ACCO Brands, Inc.

Request of Class II Permissive Change

FCC ID: GV3M01678-D

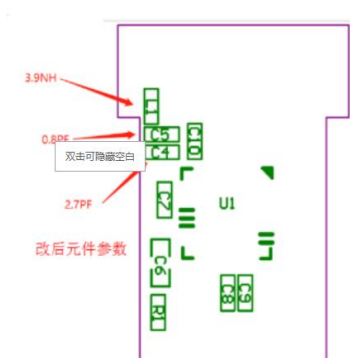
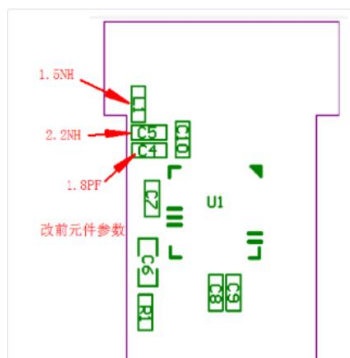
1. Change internal accessories of the product:
 - a. original-L1: 1.5NH; new-L1: 3.9NH.
 - b. original-C5: 2.2NH; new-C5: 0.8PF.
 - c. original-C4: 1.8PF; new-C4: 2.7PF.

The changes are not related with the other RF parameters, only "radiation spurious emission" of M01678-D were retested, other data were referred to the original report.
